INTRODUCTION

OUTLINE OF NEW FEATURES

The following changes are made for the new model.

SRS Curtain Shield Airbag

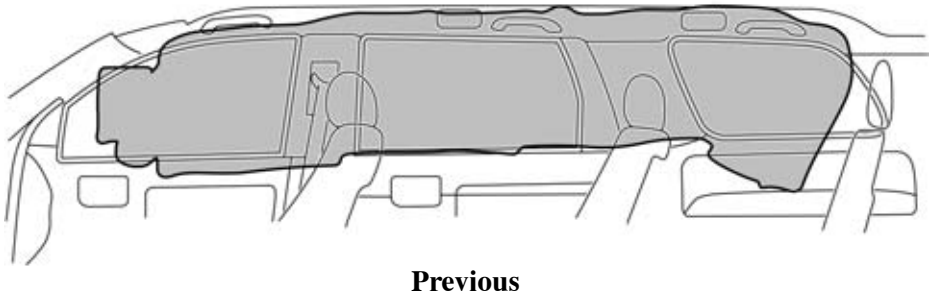
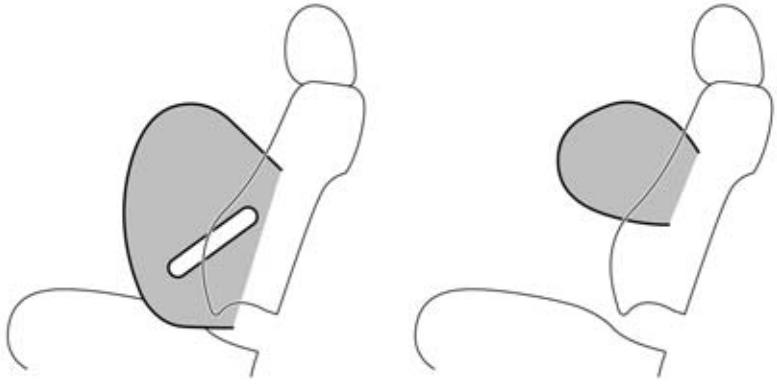
- The RSCA OFF switch and RSCA OFF indicator light have been discontinued.
- The side airbag RH/LH and curtain shield airbag RH/LH shape have been changed.
